Addendum No. 02

File Reference Number: RFP 2024 062

Title: Engineering and Design Study for Exhaust Fan Upgrades and Replacement

RE: Clarifications/Questions

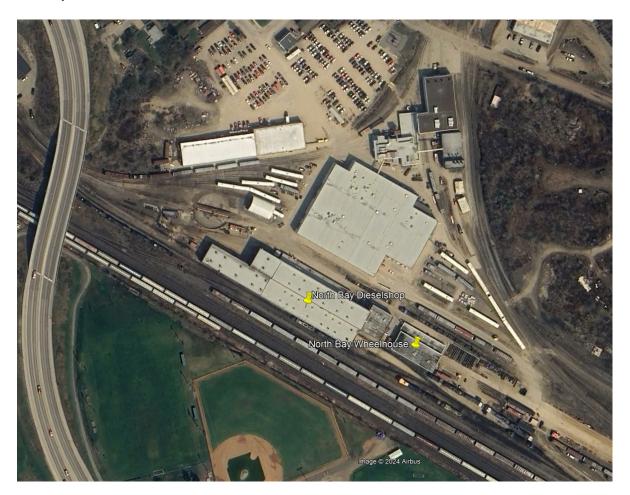
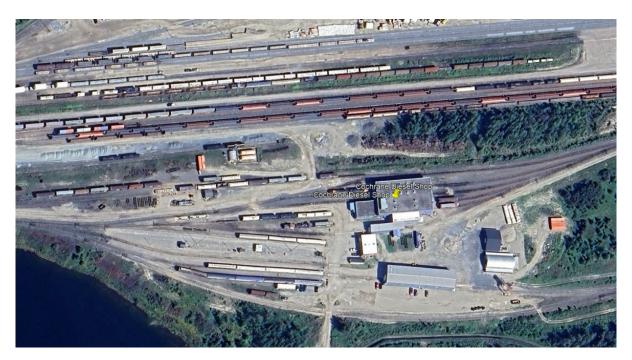
Item 6: How many buildings are involved? There are several visible in the attached Google Map views. Please provide clarification as to which building(s) are part of the scope of work?

Answer: There are three (3) buildings involved. See Screenshots below

North Bay:

Cochrane Diesel Shop:
